Somerville High School

SHS School Building Committee Meeting

December 12, 2016

Value Management Opportunities

VE-065:

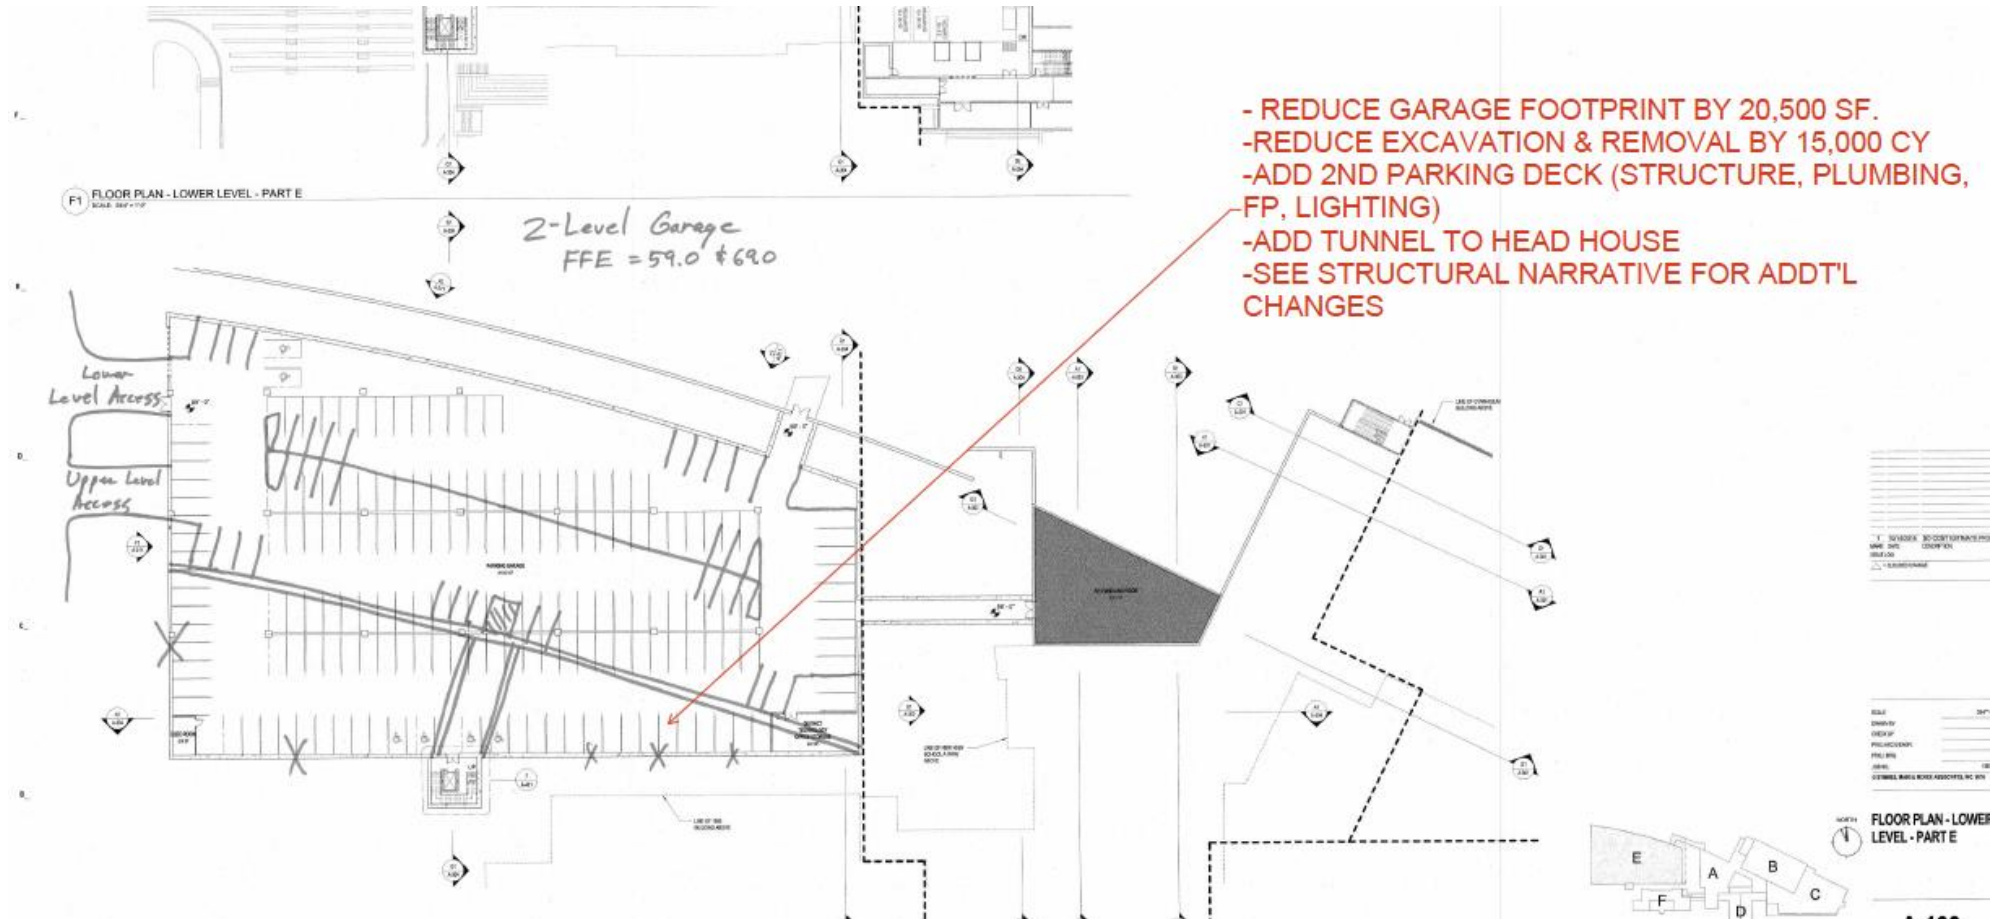
Change to two levels of structural parking, cut footprint in half and add second entrance on higher elevation on School Street.

VE-066:

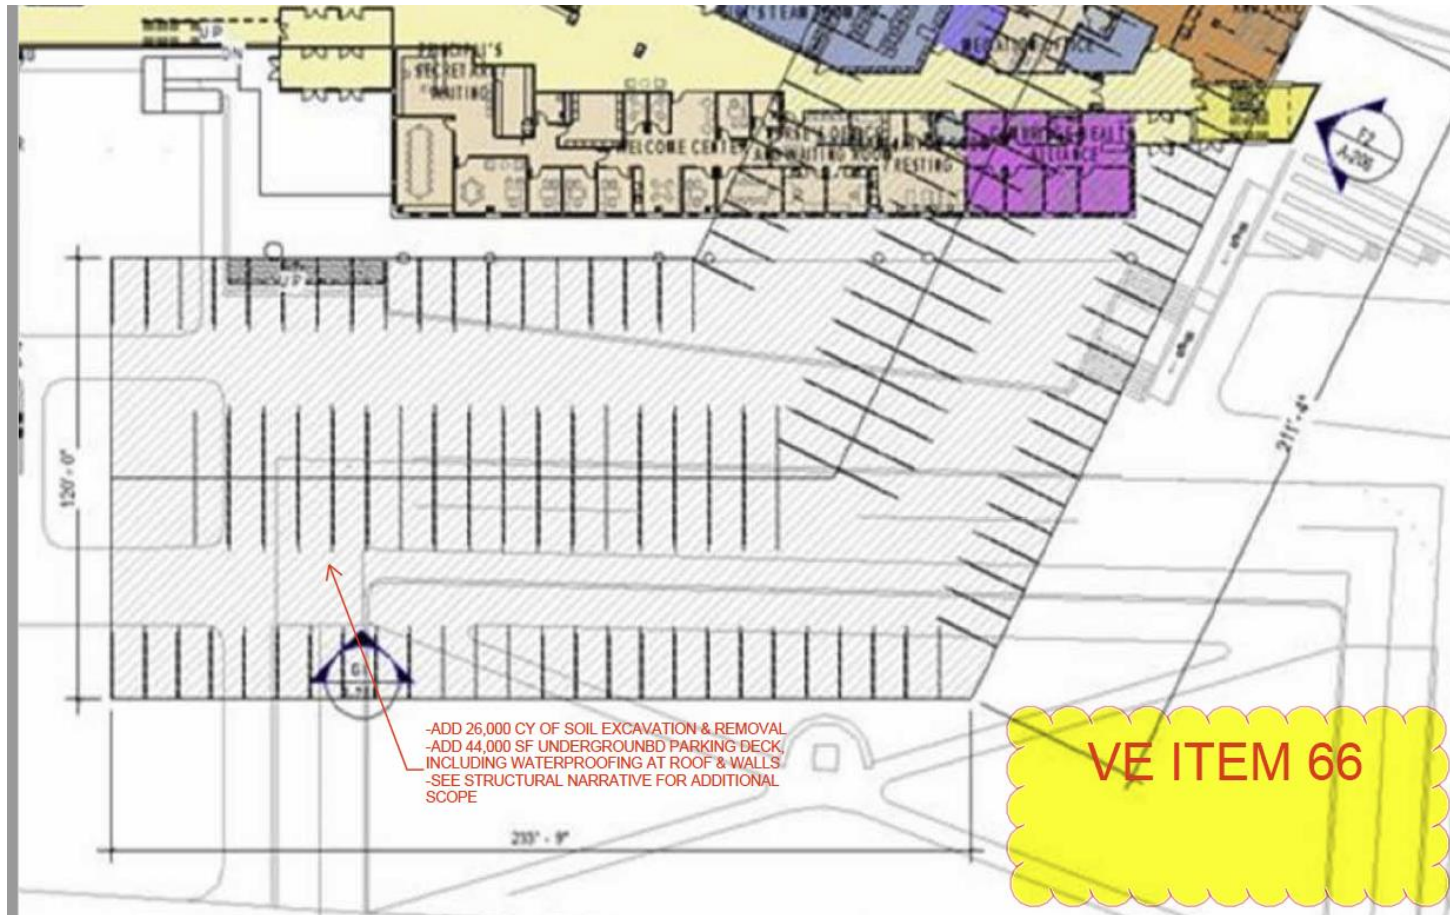
Shift parking garage to eastern side of the site below the HS building, maintaining loading, field and circulation at the western side

VE-067:

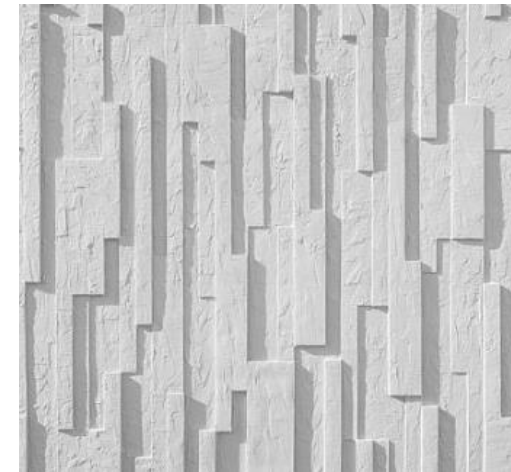
Eliminate brick veneer at Parking Garage, use form
liner for the CIP wall

VE-070:

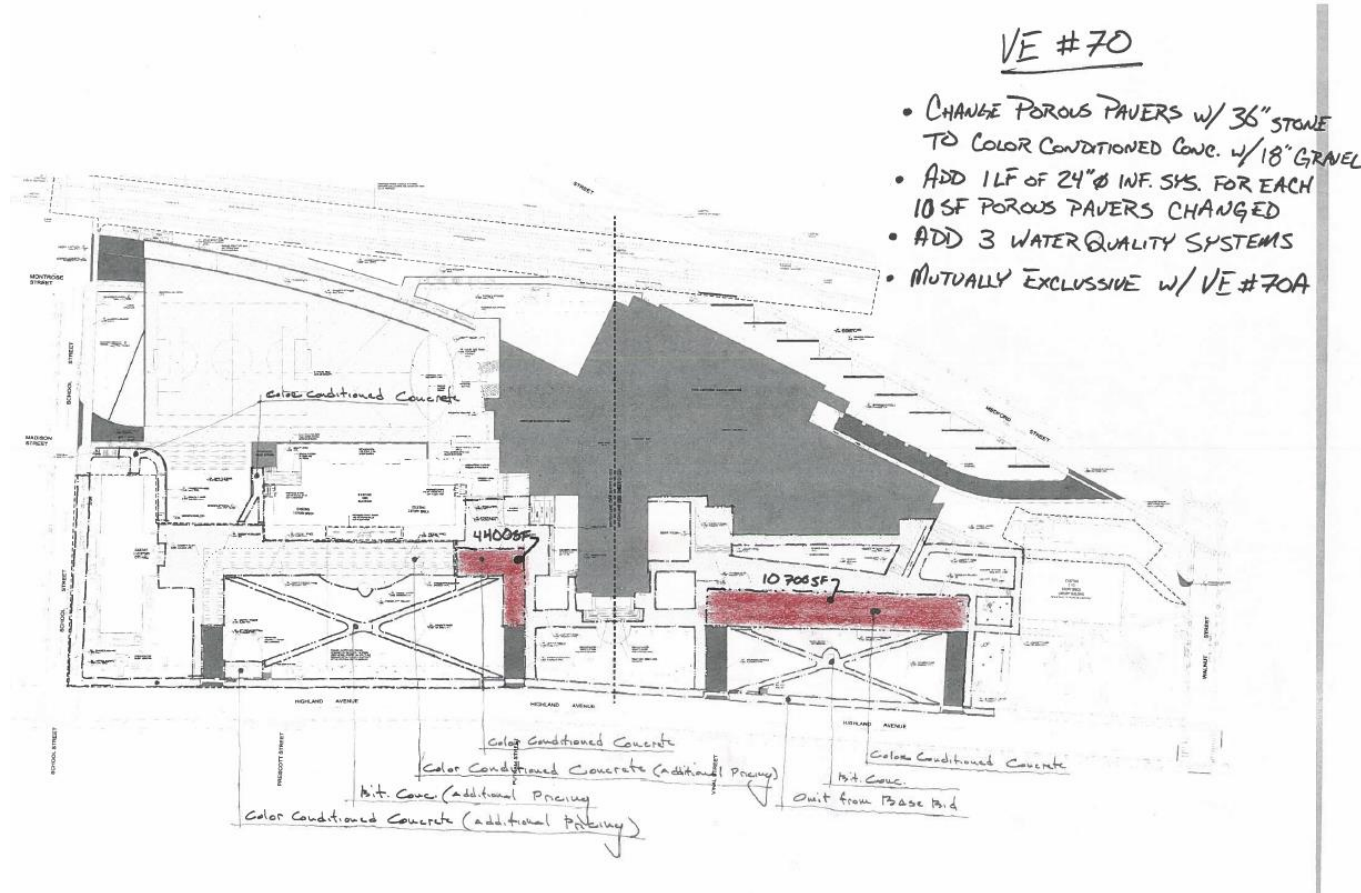
Change precast roadway pervious pavers to concrete paving

VE-071:

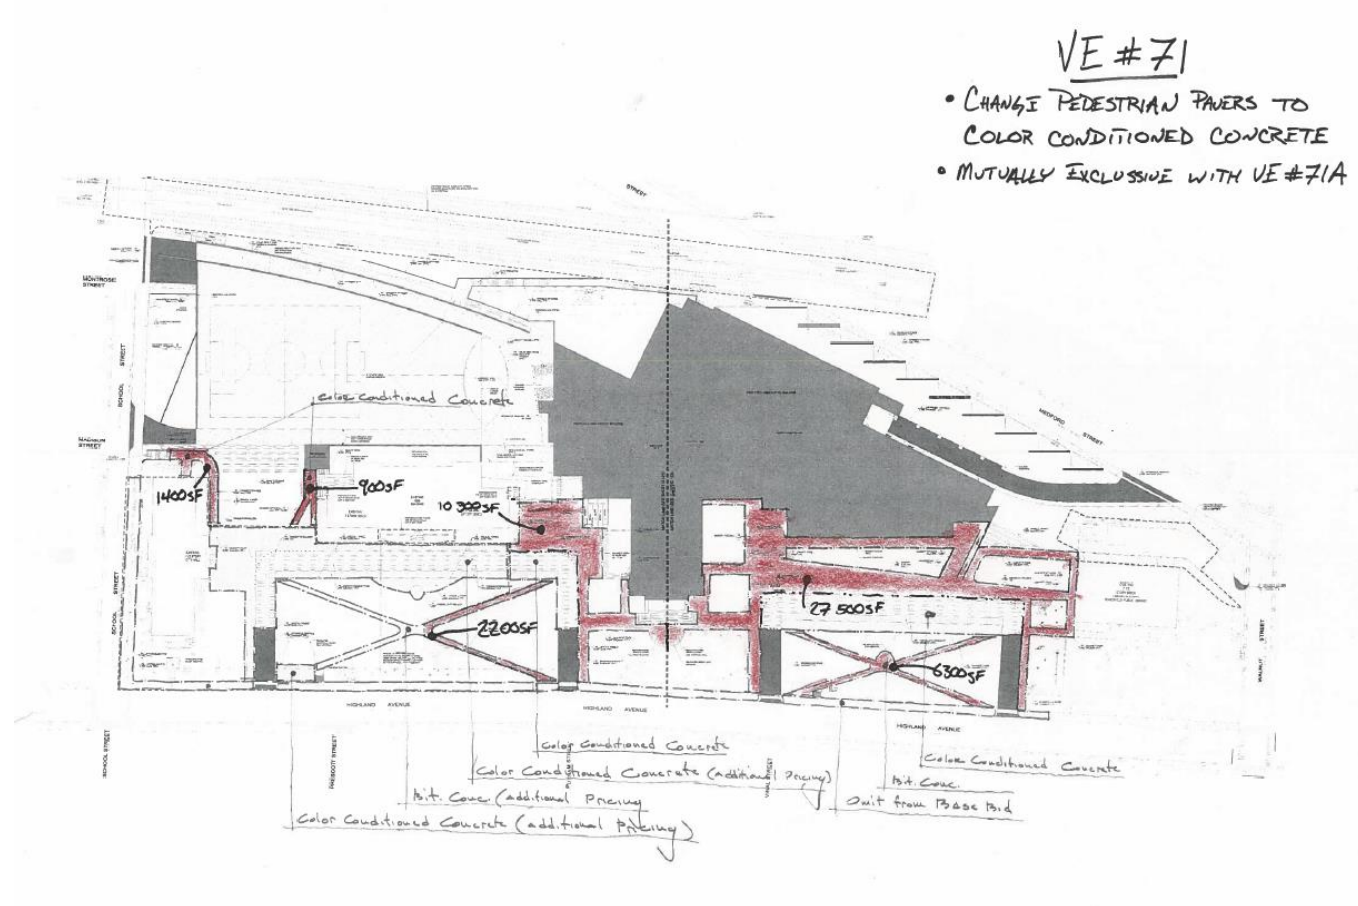
Change precast roadway pervious pavers to bituminous asphalt paving

VE-070A:

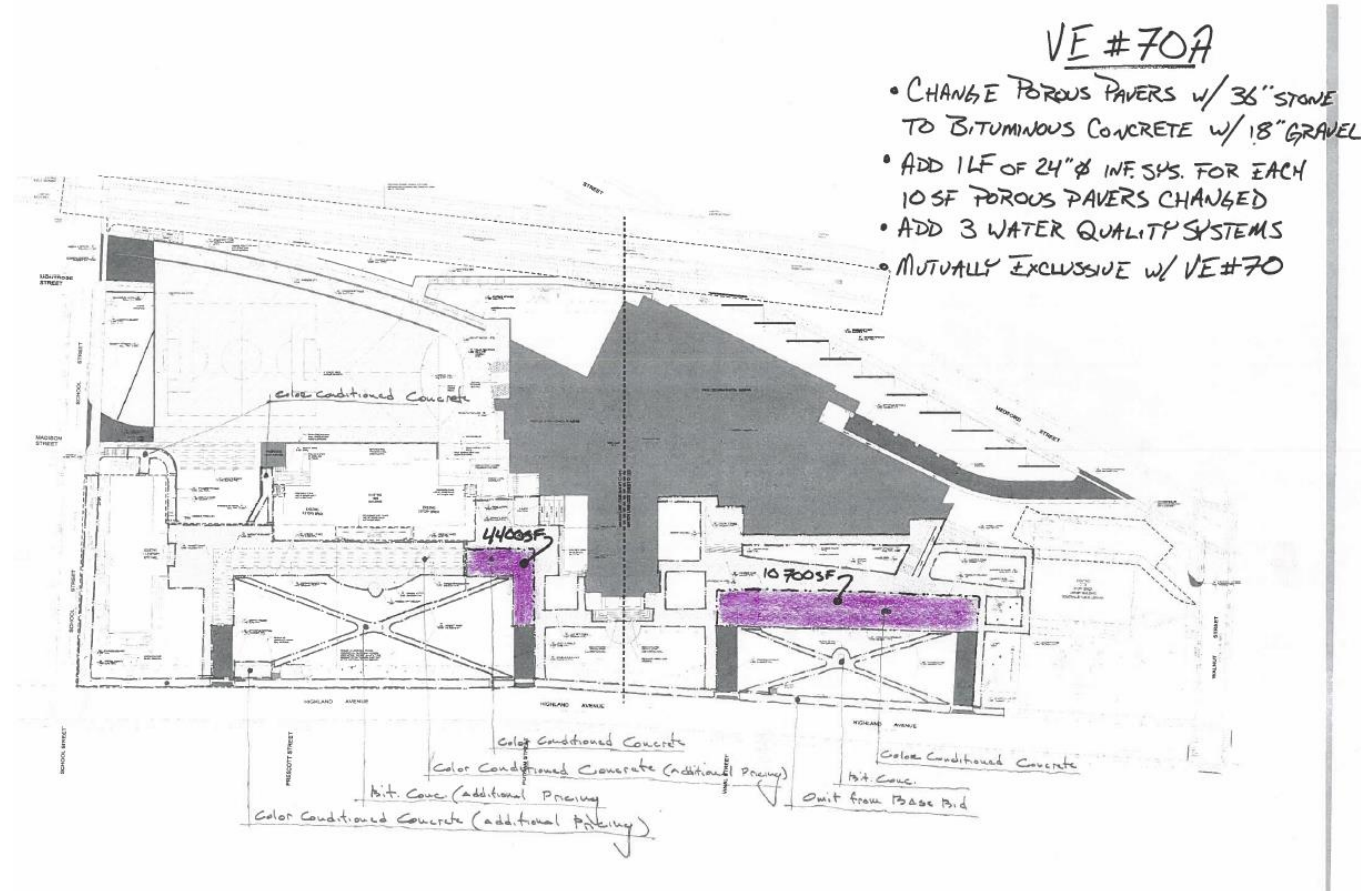
Change precast pedestrian impervious pavers to concrete paving

VE-071A:

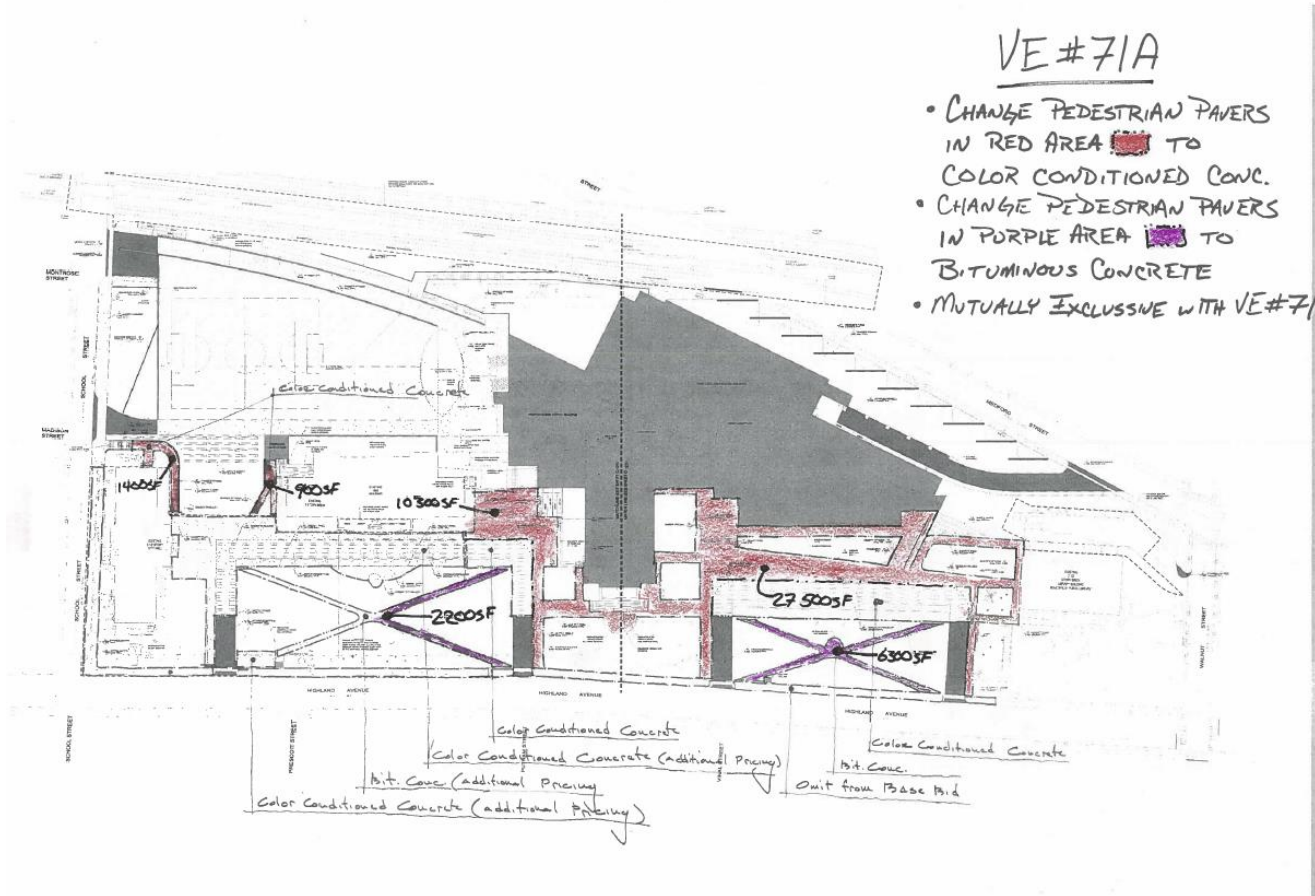
Change pedestrian concrete at greenway in front of HS only to bituminous asphalt paving

VE-074:

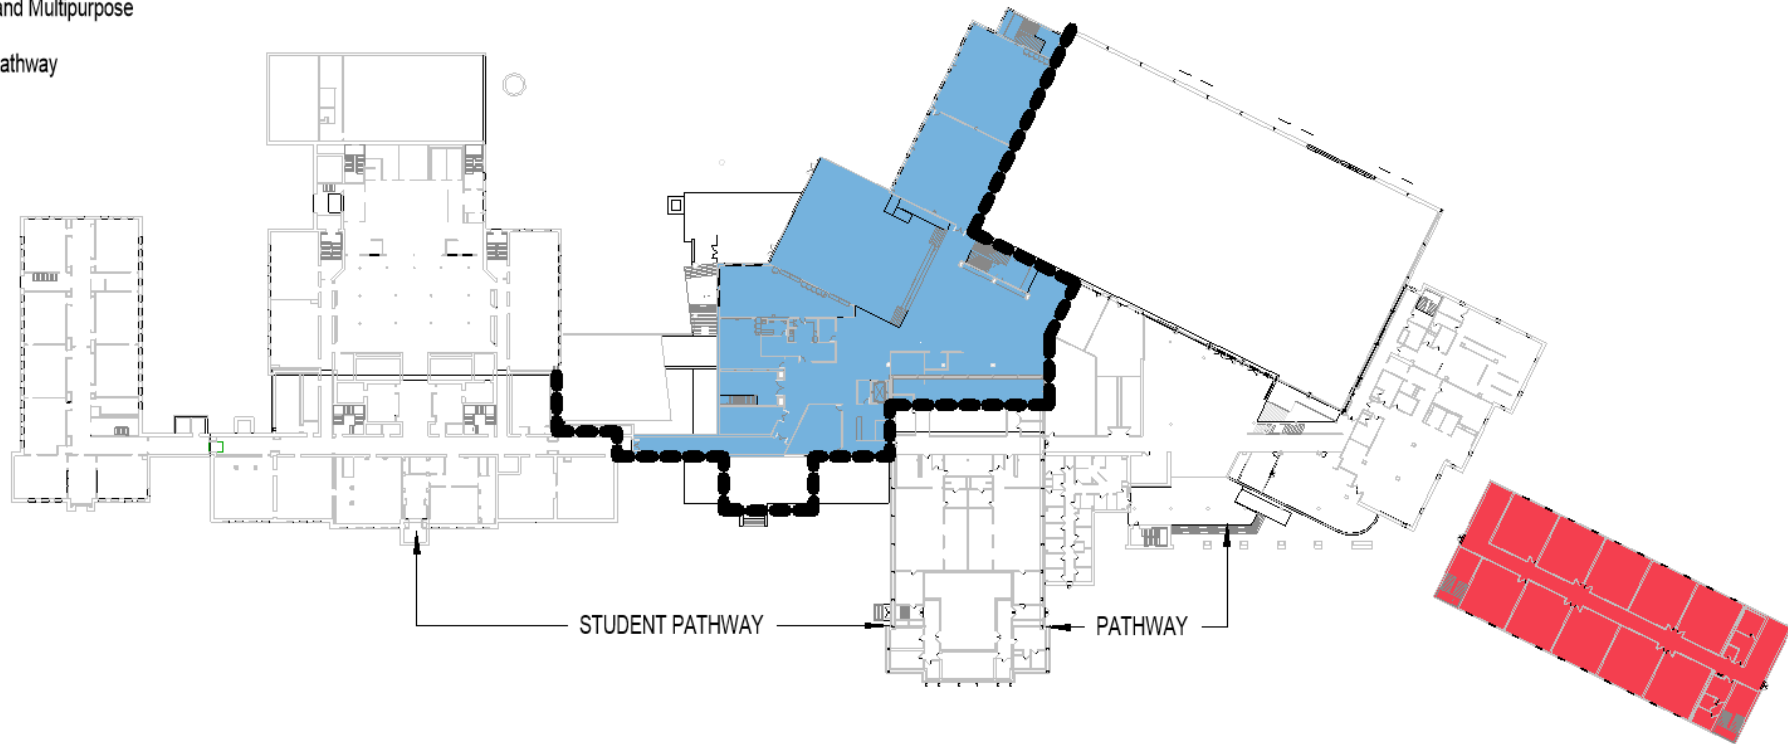
Modify the demarcation line of Phase ½ to preserve more of the existing HVAC infrastructure

VE-077:

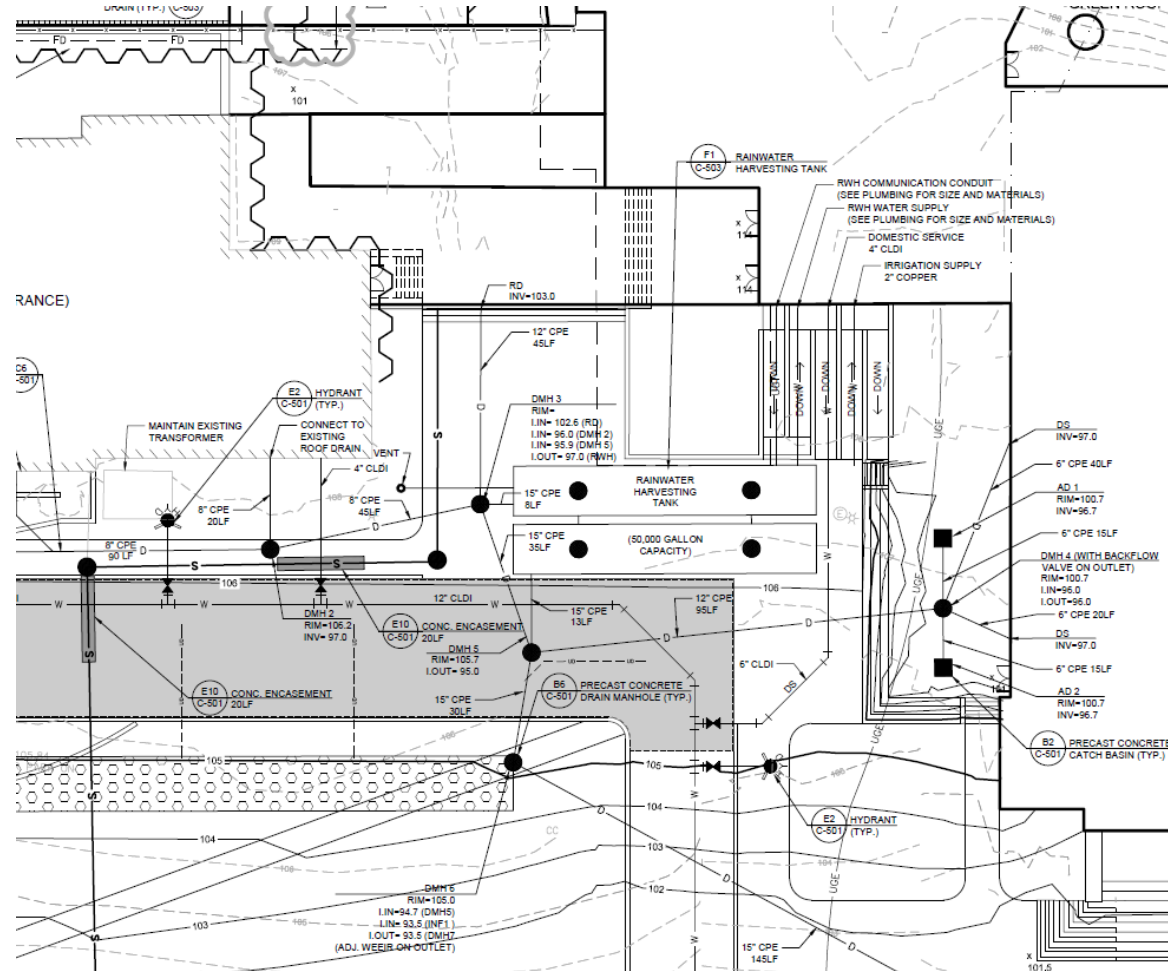
Eliminate reclaimed stormwater pipe including graywater flushing at First Floor toilets only, still using rainwater harvesting for irrigation needs
